**PROCESS SYSTEMS INTERNATIONAL
DOCUMENT REVIEW CHECKLIST**

PROJECT NAME: L16-0
PSI DOC. NO. V049-8-299

50 CFM AIR COMPRESSOR

PSI DWG # V049-8-299

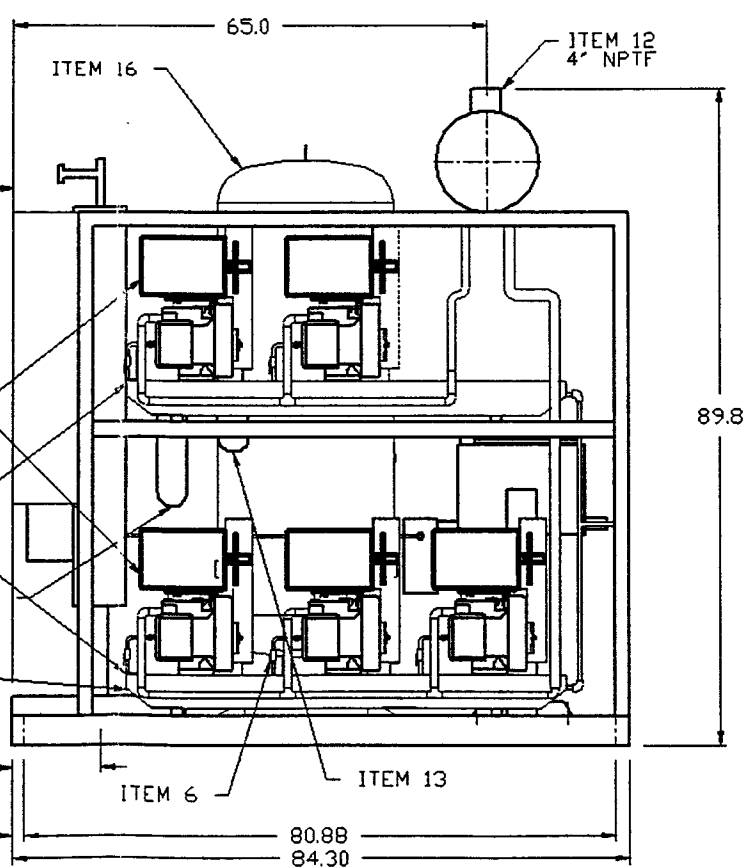
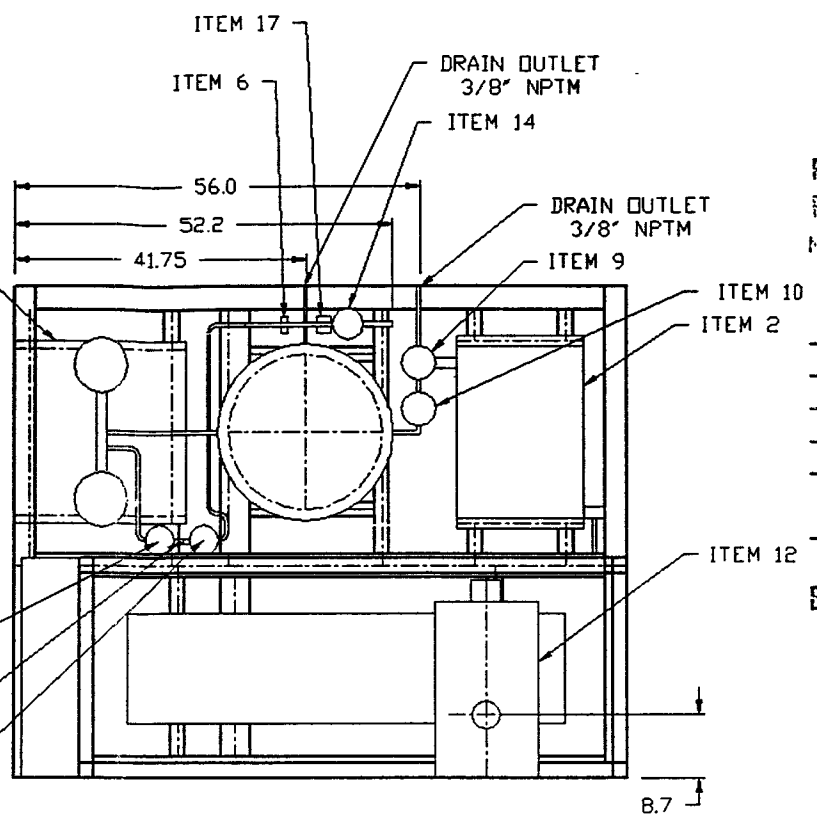
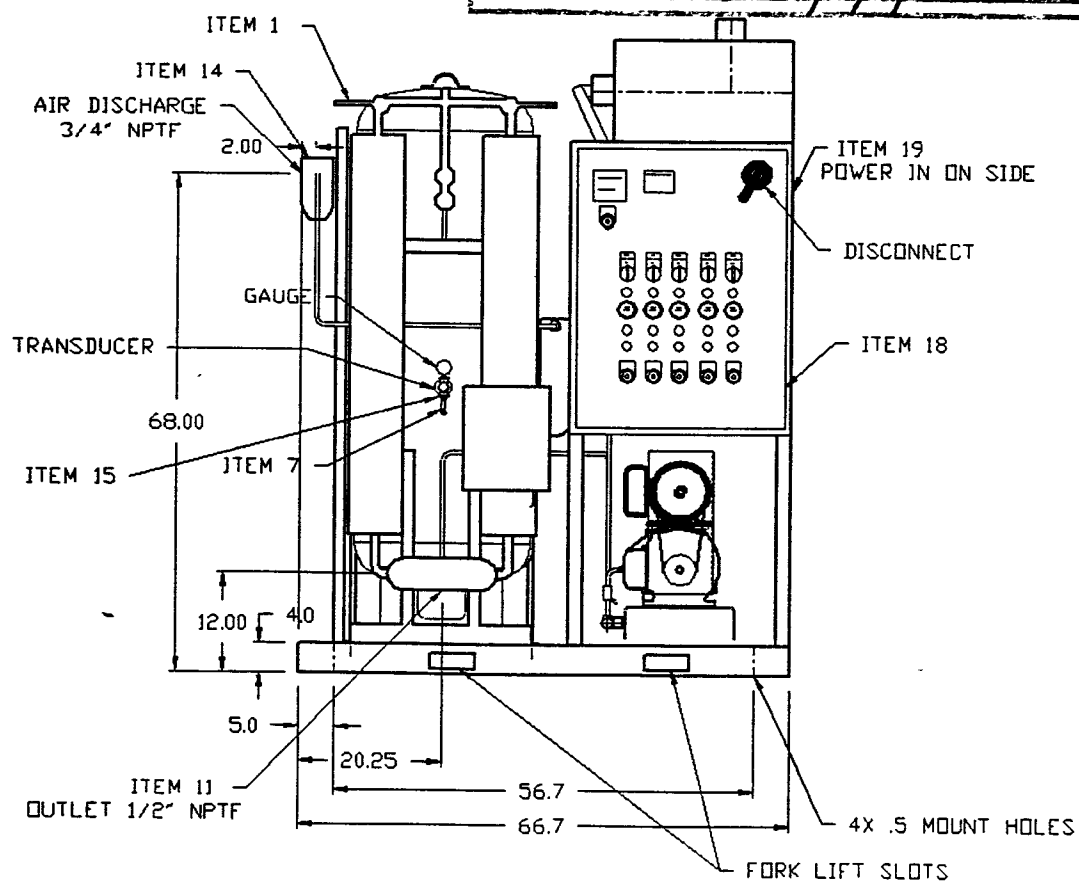
FILTER DIMS ONK

VENDOR NAME: JPL SAMPLE CONNECTION WITH ITEM 6
 REVISION NO: A8
 SUBMITTAL NO: 7
 STATUS: rev/app
